Service Information

Category R	Repair Guidance	Ref. No. R072/13G	Page 1 of 5
Coverage <input type="checkbox"/> Distributor only <input checked="" type="checkbox"/> Please inform your dealers		Date Issued September 19, 2013	
Please convey this information to your <input type="checkbox"/> Director <input checked="" type="checkbox"/> General Manager <input checked="" type="checkbox"/> Warranty Dept. <input checked="" type="checkbox"/> Parts Dept. <input checked="" type="checkbox"/> Training Dept. <input checked="" type="checkbox"/> Field Rep.		Date Revised November 15, 2017	
Applicable Model Mazda3 (BM/BN), Mazda6 (GJ/GL) and CX-5 (KE/KF)		Applicable Countries or Specifications Worldwide (except North America)

Subject: Creaking Noise from Front Lower Arm Bushing when driving over bumps in wet condition

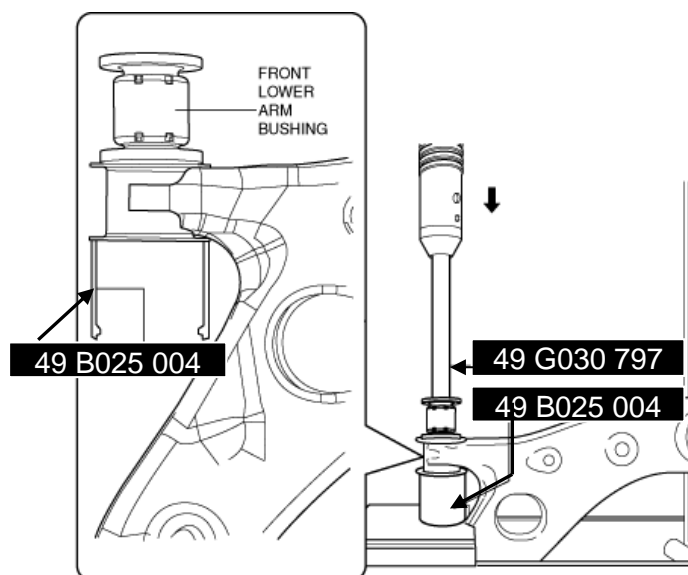
1. Verify if the noise occurs when driving over bumps in wet condition.
2. Replace the Front Lower Arm Bushing (both sides) with a modified one using the following procedure.
 - 2-1. Remove the Front Lower Arm (both sides) following the procedure in the Workshop Manual "FRONT LOWER ARM REMOVAL/INSTALLATION".
 - 2-2. Remove the Front Lower Arm Bushing using the SSTs.
Set SSTs (**49 G030 797** and **49 B025 004**) and the Front Lower Arm on a shop press as shown in the figure and remove the Front Lower Arm Bushing.

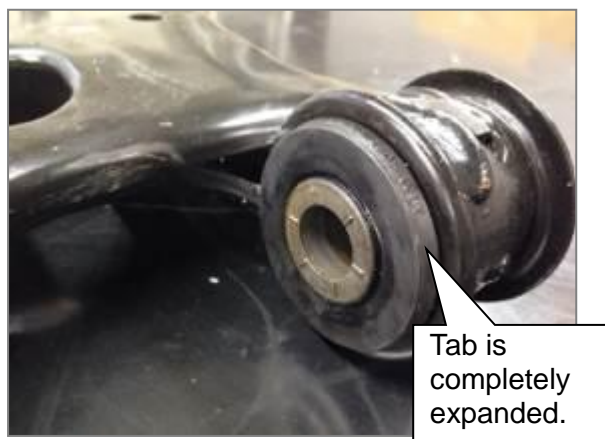
CAUTION: Make sure that the bushing has been properly inserted by checking that the tab of the bushing is completely expanded as shown in the OK illustration.

OK: Properly installed

NG: Improperly installed

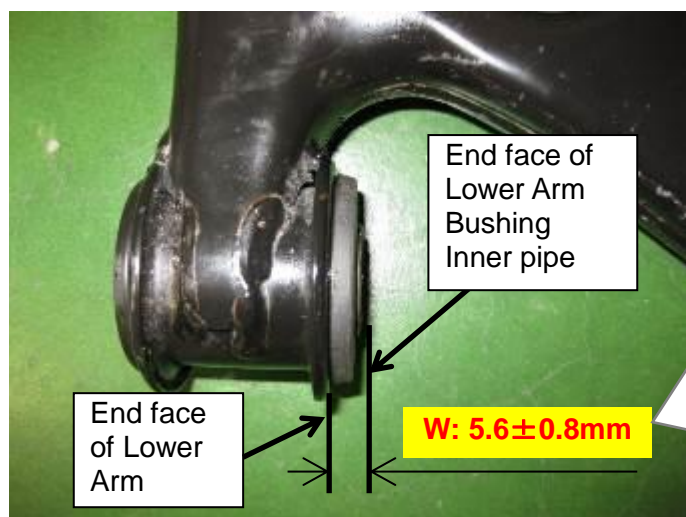
- 2-4. After installing the Front Lower Arm Bushing, verify that it is installed to the position shown in the figure.

Measure the width as shown in the figure.
